CITY OF ALBUQUERQUE

RE: **Applebee's
Grading Plan
Engineer's Stamp Date 2-27-2015 (File: K09-D038)**

Based upon the information provided in your submittal received 2-27-15, the above referenced Grading Plan cannot be approved until the following comments are addressed:

drawing title
Grading Plan

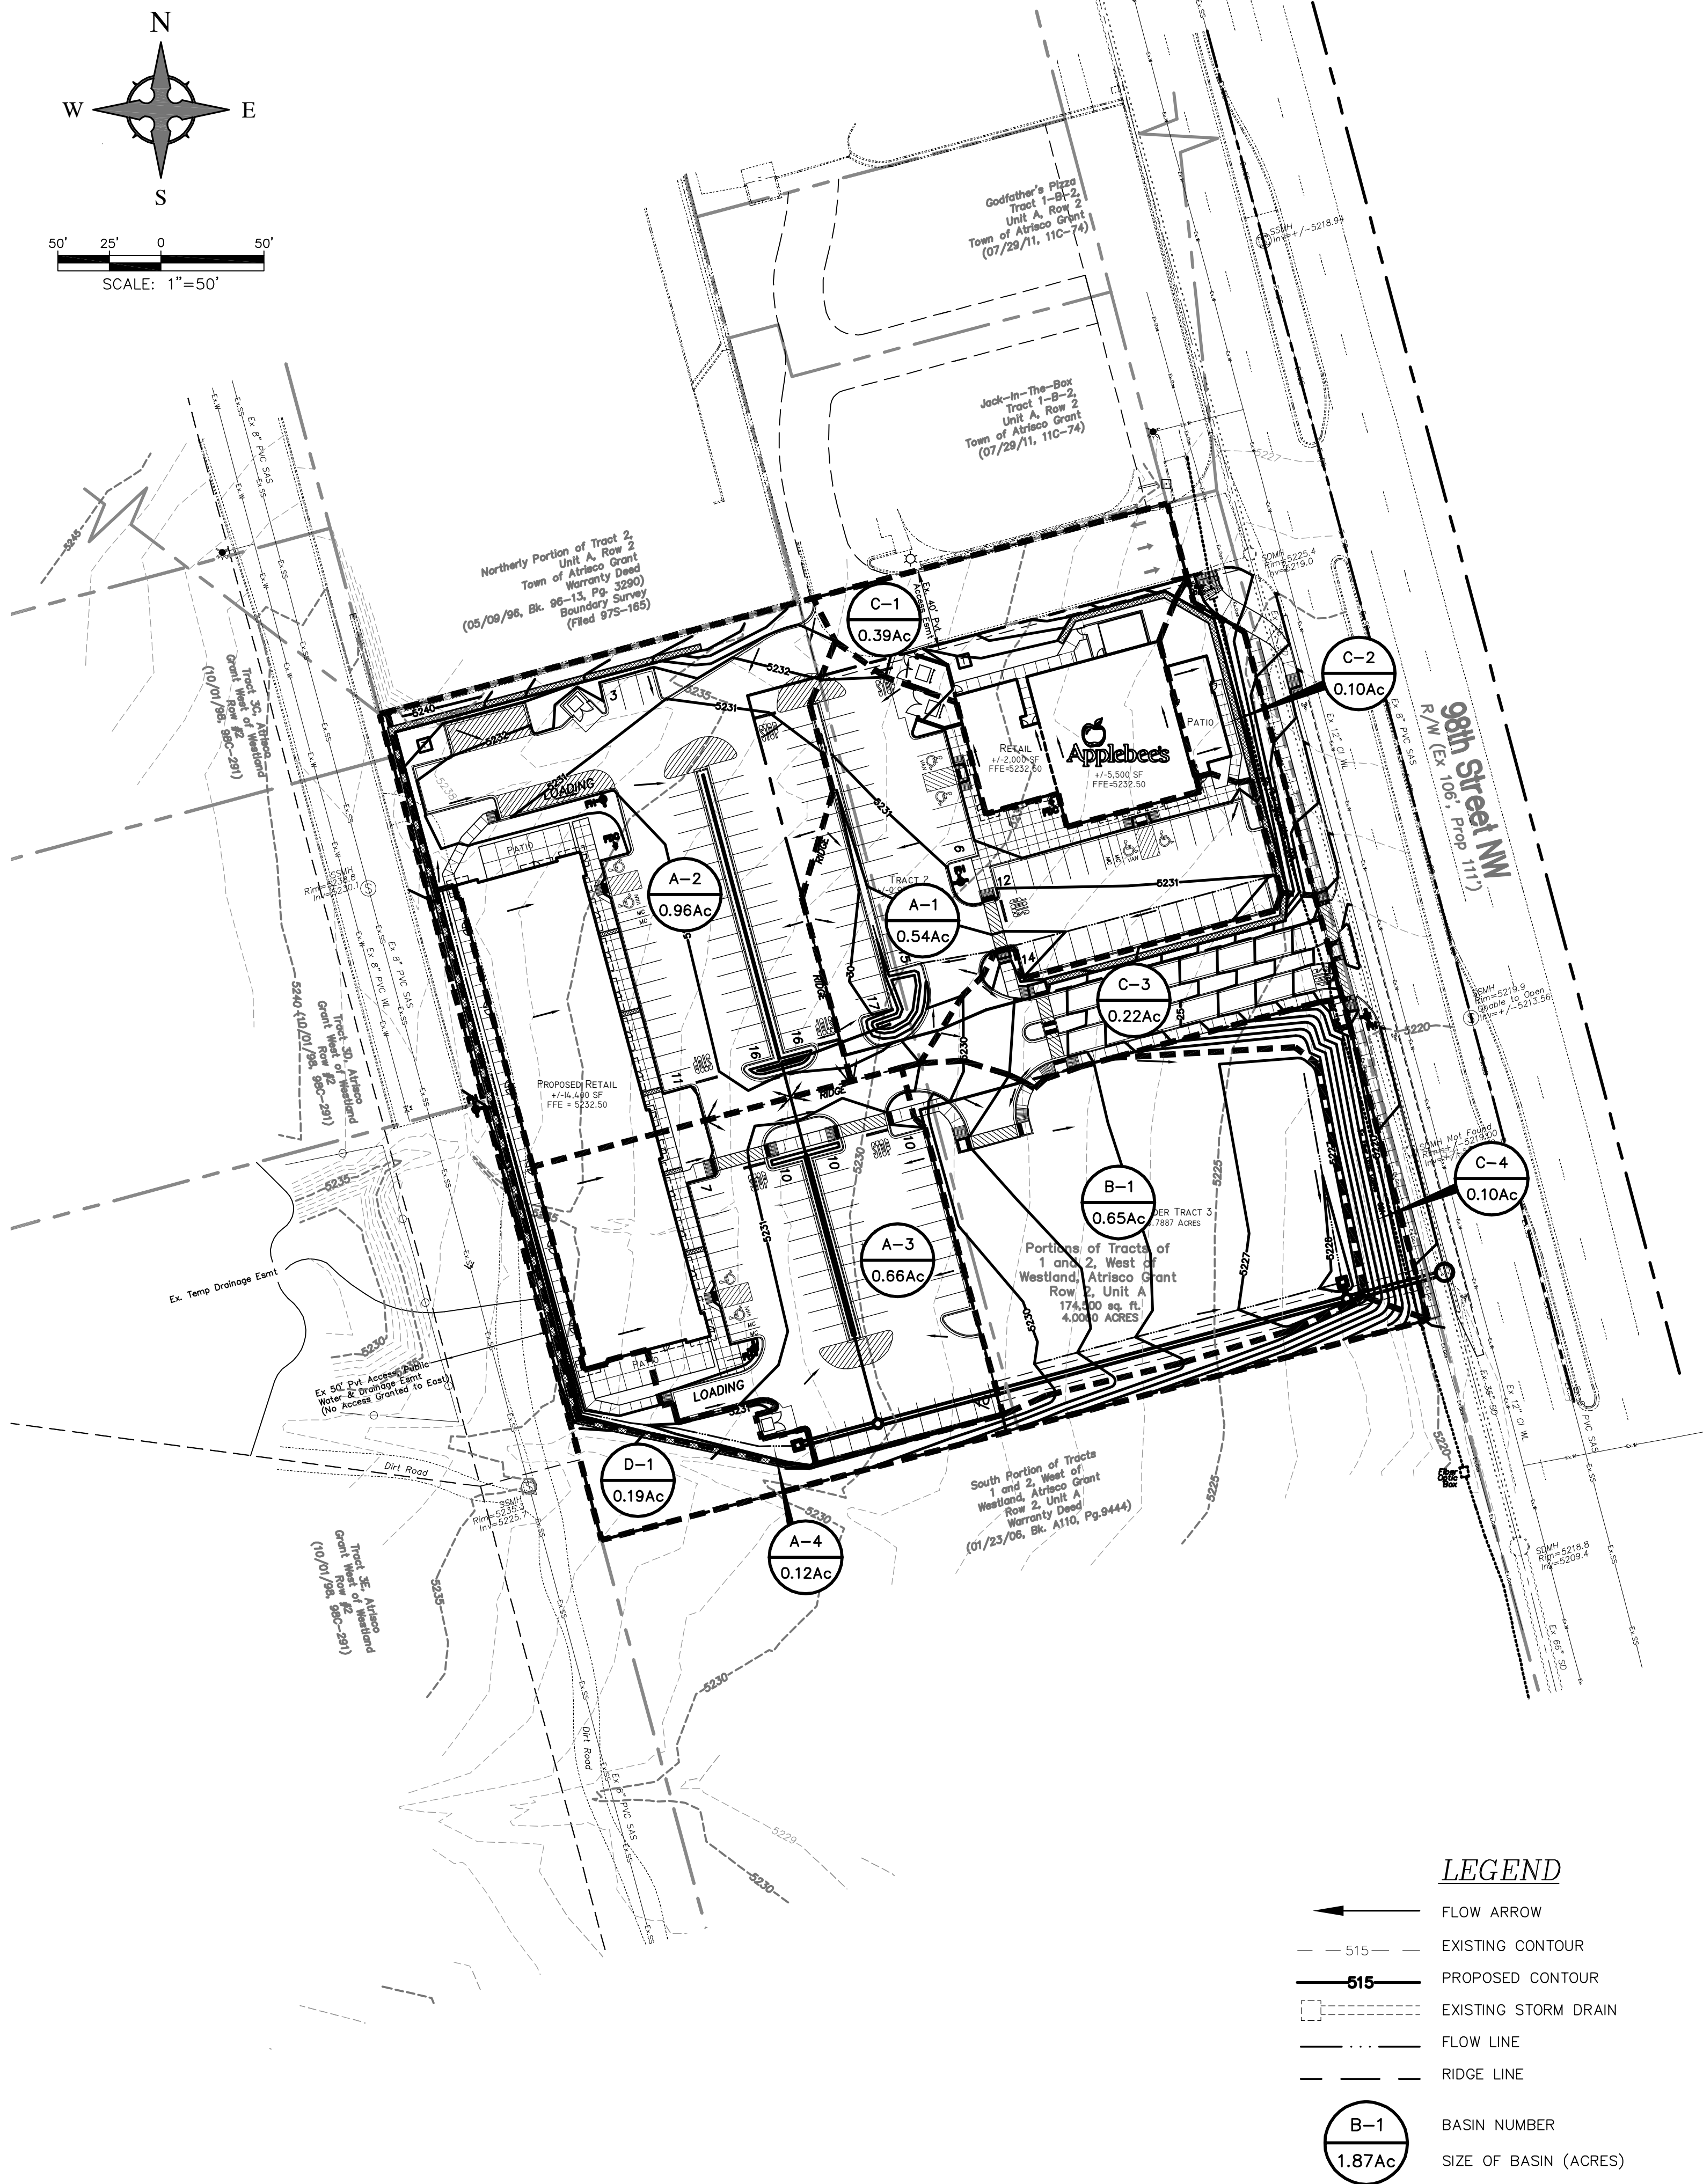
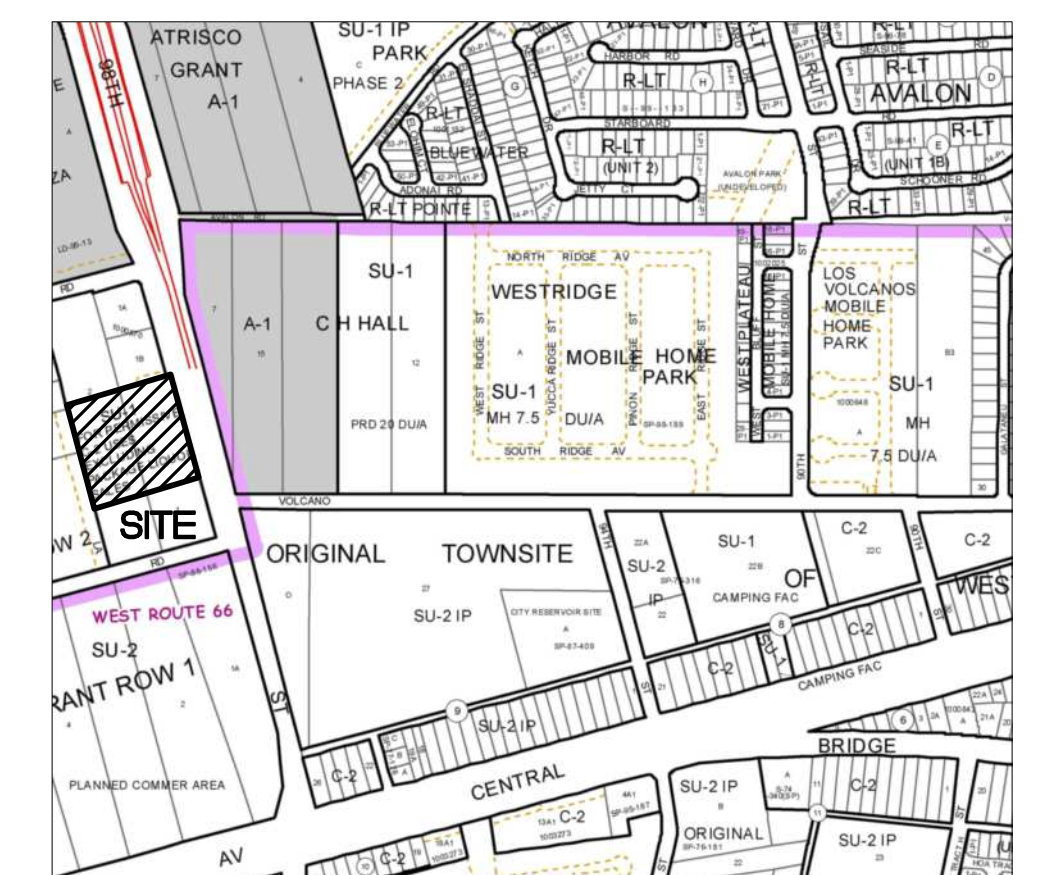
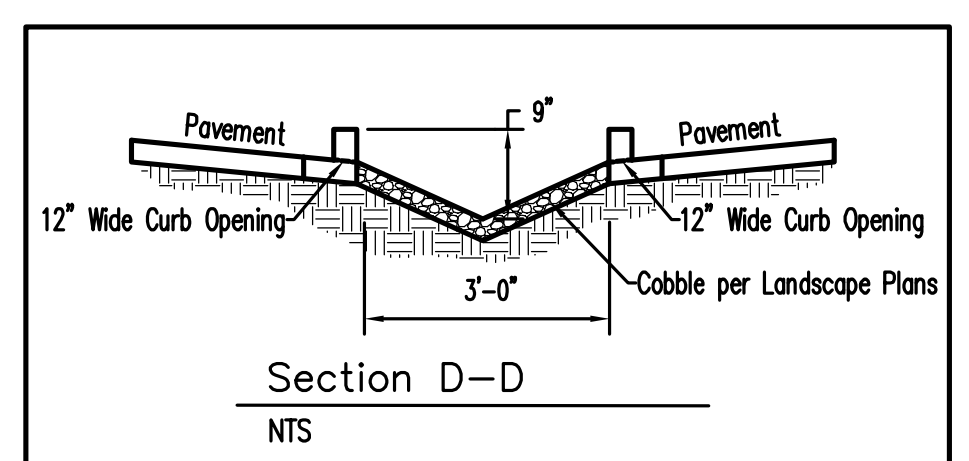
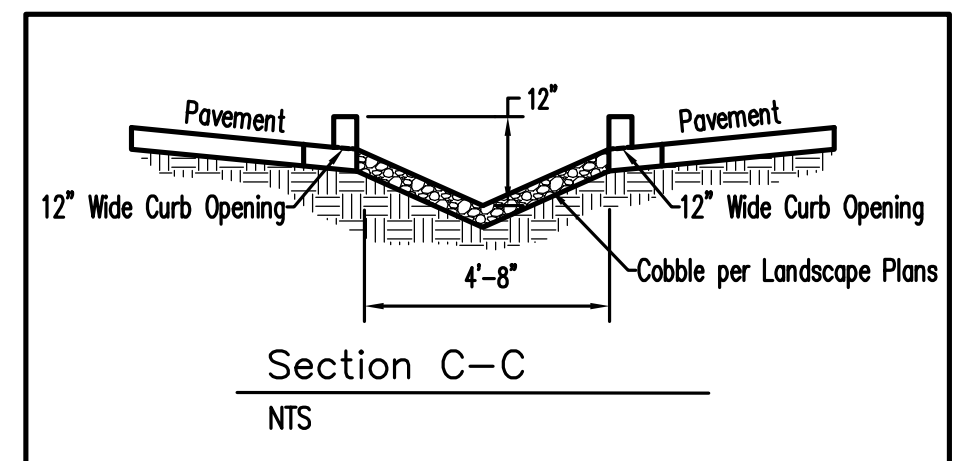
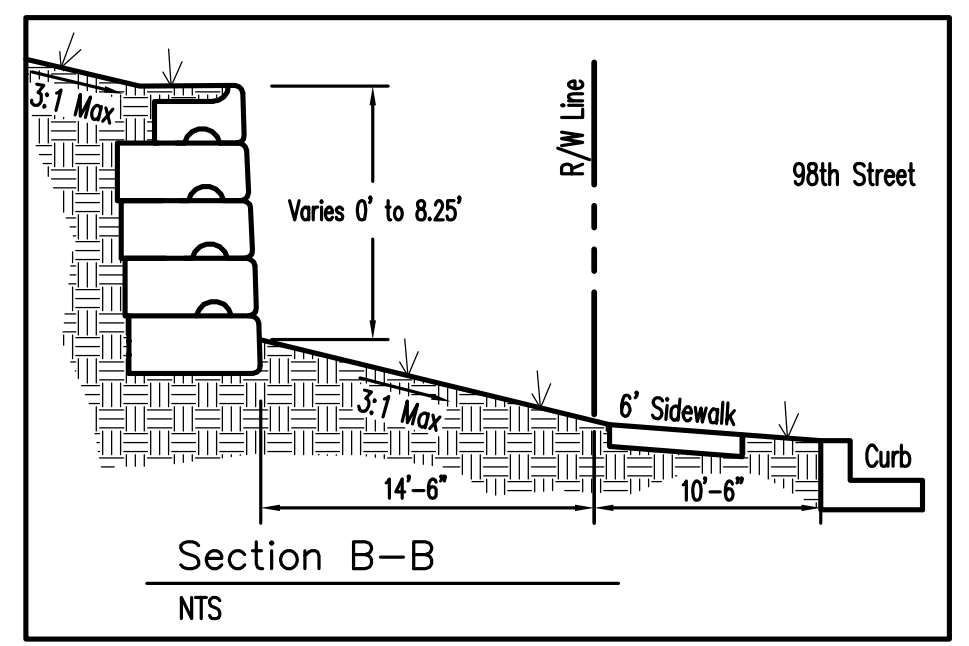
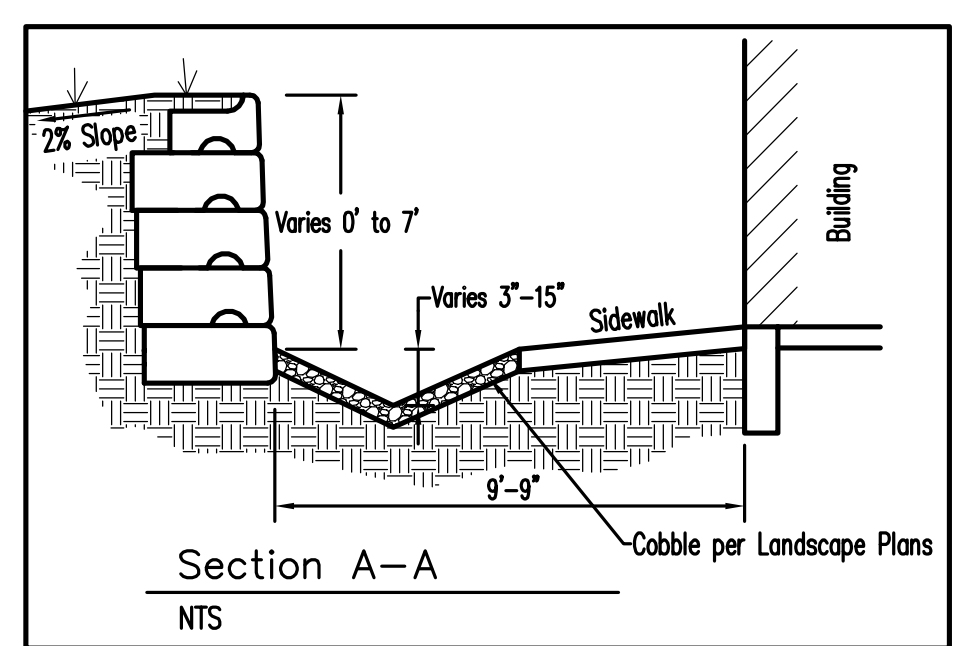
- 1) For 98th Street, label curb and gutter flowline and top of curb elevations. Label sidewalk elevations to show that the subject site is draining to the street. Also, show and label all proposed inlets on the grading plan along with grate elevations.

- 2) On the Grading Plan, for the on-site drainage system, label the flow that each of the pipe runs is conveying. Provide capacity calculations for both the on-site storm drainage pipes and the inlets.

- 4) The curb cuts need to be shown in the low spots for the water harvesting areas in between the parking spaces. It makes more sense to have curb cuts where FL Elevation 29.00 is shown for the island instead of upstream close to where Section D-D is shown. Provide capacity calculations for the curb cuts. (You have called out more curb cuts on the Traffic Circulation Plan, but all of these curb cuts need to be called out on the Grading Plan since they influence drainage.)

- 5) All water harvesting area should be labeled as such, and conceptual flow arrows and spot elevations should support the concept. Include discussion of the various individual water harvesting areas in the report write-up. Why is over 15,000 square feet cubic feet of volume being provided if only 3,091 cubic feet is required? Also, due to the amount of impervious area for the Applebee's building alone, provide a water harvesting area north of this building.

6) An elevation of 29.50 is provided next to the inlet on the southwest corner of the site which is lower than the inlet grate. Is this a water harvesting area? If so, label it as such.

7) Show proposed pad height for future building on Tract 3.

Drainage Calculations

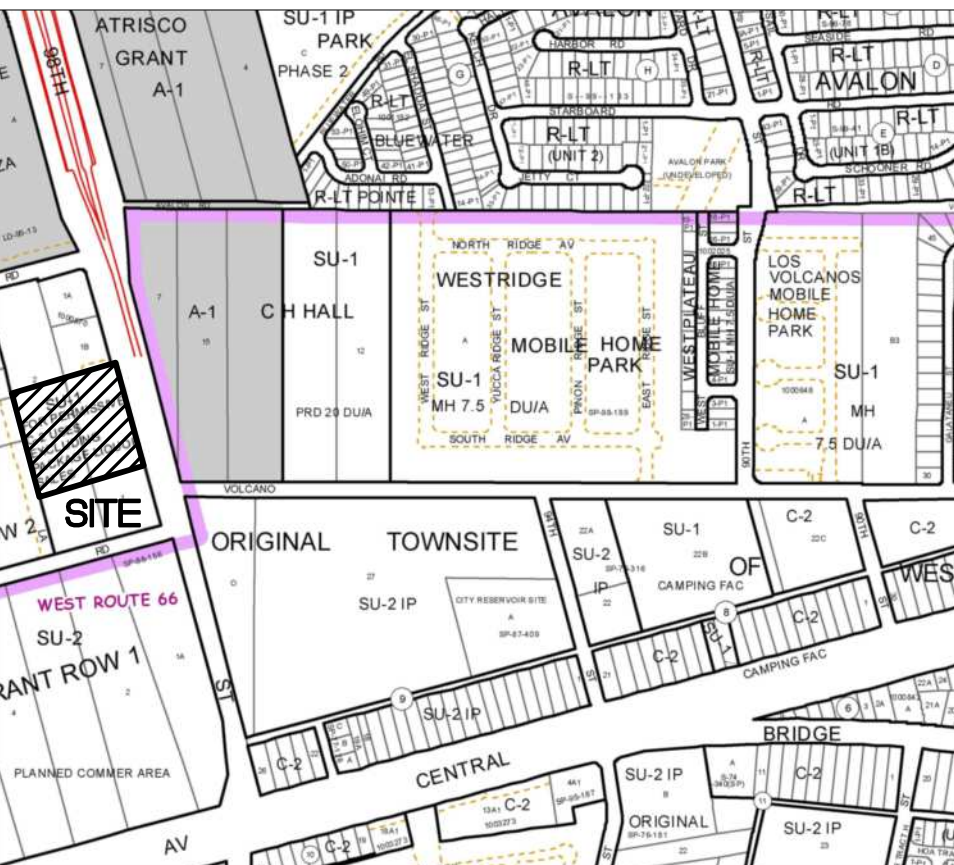
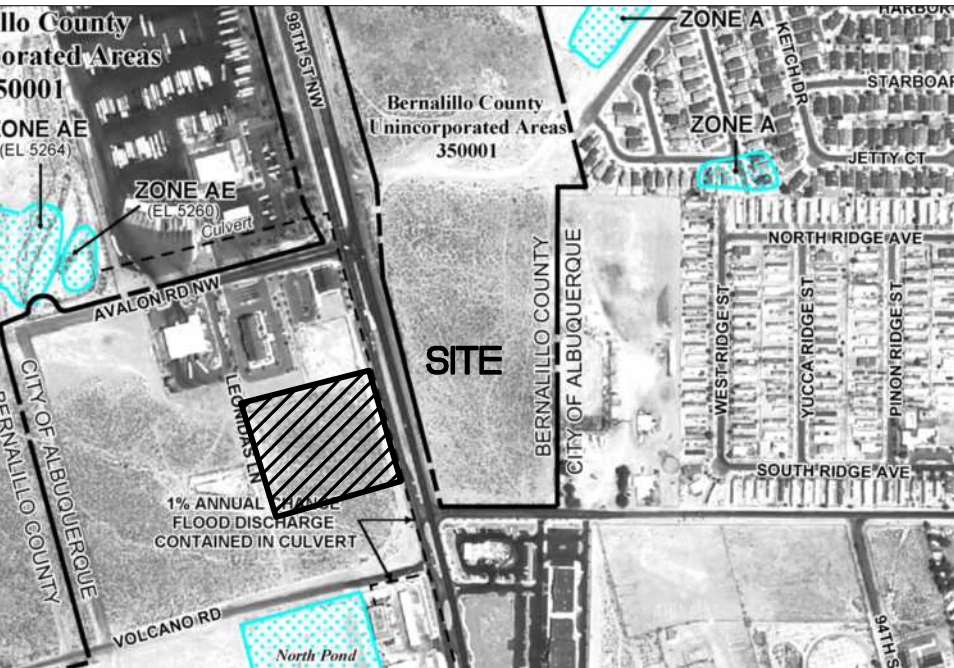
- 3) In your write-up on the Drainage Calculations sheet, include discussion of off-site flows. Also, mention how the grading of this site will not negatively impact adjacent sites.
